# Road Safety Audit Report

**Incorporating  
Stage 1 Completion of Preliminary Design;  
Design Organisation Response to items raised; and  
Auditor's View on the Design Organisation Response.**

## **Proposed Footpath Cyclepath Emergency Access onto Tukes Avenue Fareham**

**Client reference:**  
ITB10353-023

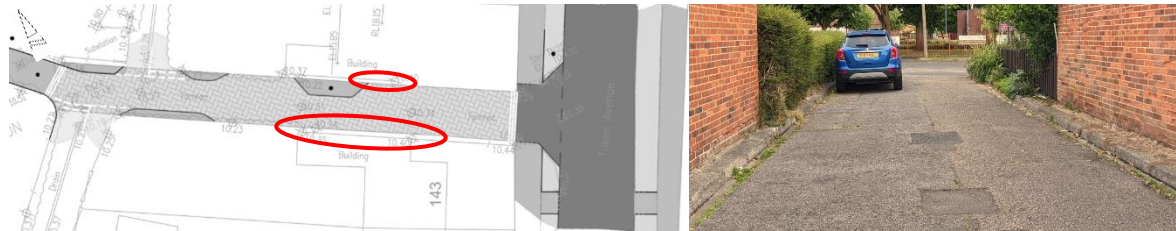
<b>A.2.5</b>	<b>PROBLEM</b>
<b>Location:</b>	Service Road
<b>Summary:</b>	Provision of resurfacing may remove the margin between the path of a vehicle and adjacent properties
<b>Acc Type:</b>	Vehicle collision with property structure

The existing service road is circa 4.2 metres wide and benefits from a narrow kerbed margin between the concrete carriageway and boundary / side wall of the adjacent properties. The proposals include highway works to the existing service road to allow access to a footway cycleway emergency access associated with a development of 375 dwellings to the west. The scheme drawing notes that ‘link to be re-surfaced’ and the ‘access revised to a vehicle crossover arrangement ...’. No details of the proposed resurfacing have been provided at this stage, however, the Audit Team have concerns that the provision of a vehicular crossover will raise the

carriageway to the height of the margin which could lead to vehicle travelling closer to the adjacent properties and vehicle collisions with the property structure.

It is recommended that an adequate margin is retained between the carriageway and adjacent properties.

Agreed – the existing margin between the carriageway and adjacent properties is to be retained and is annotated on Drawing ITB10353-GA-032

Confirmation that the existing margin is to be retained, addresses the road safety concern at this stage.

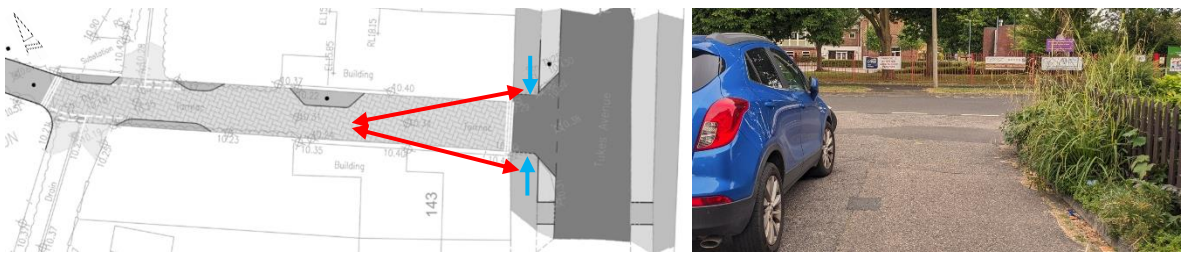
**Summary:** Visibility between cyclists and users of the rear access road is limited

The existing service road forms a link between Tukes Avenue and the application site via a field gate as well as providing access to the rear access road associated with properties to the north and south. As observed on-site, vegetation and property boundaries restrict visibility from the rear access road. The proposals include works to upgrade the service road to allow access to a footway cycleway emergency access that accommodates a removable bollard to restrict general vehicular access. The scheme drawing provided with the Audit Brief illustrates that give-way road markings are to be provided at the rear access road junction with the service road and that a buildout is to be provided both sides of the carriageway just to the east. The proposed buildout increases the level of visibility that is achievable, however, the Audit Team have concerns that cyclists will proceed at speed on approach to the priority junctions and that the driver of egressing vehicles and cyclists will not become aware of one-another at a safe distance, which could lead to vehicle to cyclist type collisions.

<p><b>RECOMMENDATION:</b></p>
<p>It is recommended that measures are provided and existing vegetation trimmed / maintained to ensure the level of achievable visibility is adequate.</p>
<p><b>Location Plan:</b></p> 
<p><b>DESIGN ORGANISATION RESPONSE provided by i-Transport on the 20<sup>th</sup> July 2022 following formal issue of this Stage 1 Road Safety Audit on the 8<sup>th</sup> July 2022.</b></p>
<p>Agree – the alignment of the shared footway/cycleway into the site along with staggered barriers will ensure that cyclists reduce speeds on the approach to the shared surface area.</p> <p>The proposed buildouts have been revised to assist in improving visibility and encourage slow speeds.</p> <p>Vehicles egressing the access points on the north and south side currently protrude onto the access road and has been in safe operation for a significant number of years. As part of these proposals this looks to build out the junction and increase the existing visibility i.e. this arrangement is a betterment.</p> <p>Whilst this will now forms a shared use route for pedestrian, cyclists and vehicles, 9m forward visibility from both the east and west can be achieved on the approach to the access points on the southern and northern side of the access road, which allows approaching drivers, cyclists and pedestrians to clearly see any overhang of vehicles emerging from the access points. This equates to 10mph design speed.</p> <p>Visibility of 2.0m x 9.0m can be achieved to the left and right from both the southern and northern access points.</p> <p>In addition, where existing vegetation overhangs the highways, this will be trimmed back behind the proposed visibility splays.</p>

<p><b>AUDITOR’S VIEW OF DESIGN ORGANISATION RESPONSE dated 26<sup>th</sup> July 2022</b></p>
<p><i>Confirmation that the proposals increase the achievable level of visibility and measures will be provided to ensure that cyclists and pedestrians slow on approach to the existing service road, addresses the road safety concern at this stage.</i></p>
